# SEDGWICK COUNTY, KANSAS DIVISION OF FINANCE

# REQUEST FOR BID #14-0059 Lake Afton Parking Lot Paving – B5 Red Brick East Addendum #1

June 24, 2014

#### 1.9 **Gravel drive / access:**

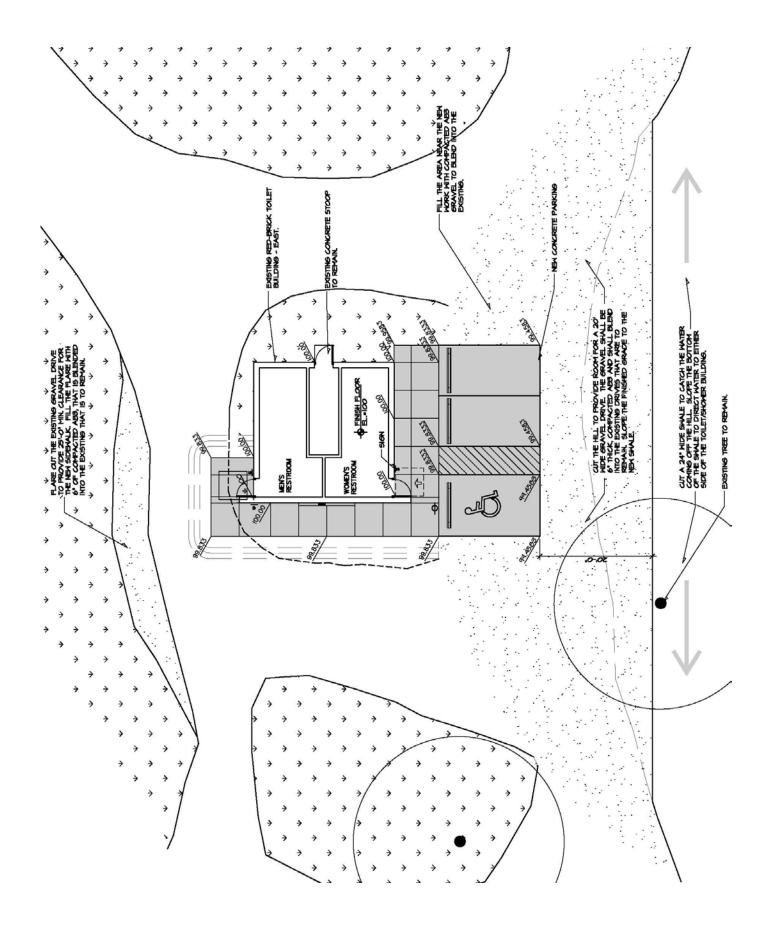
- 1.9.1 Refer to the site plan included with this addendum. Plan North shall be considered to be the top of the page.
- 1.9.2 The existing gravel drive on the East side, will be mostly displaced by the new accessible parking. A new gravel drive shall be cut into the hill. The drive shall be a minimum of 20' wide (measured from the back of the new concrete parking. The drive shall be 6" compacted AB3. The drive shall slope away from the building.
- 1.9.3 A swale shall be cut on the East side of the new gravel drive to capture storm water coming down the hill toward the drive. Slope the bottom of the swale to carry water around the new parking area. The swale will be approximately 24" wide x 120 feet long. The depth will vary.
- 1.9.4 The existing gravel drive on the West shall be expanded to provide 25' clear from the new sidewalk. The expanded drive shall be 6' of compacted AB3.
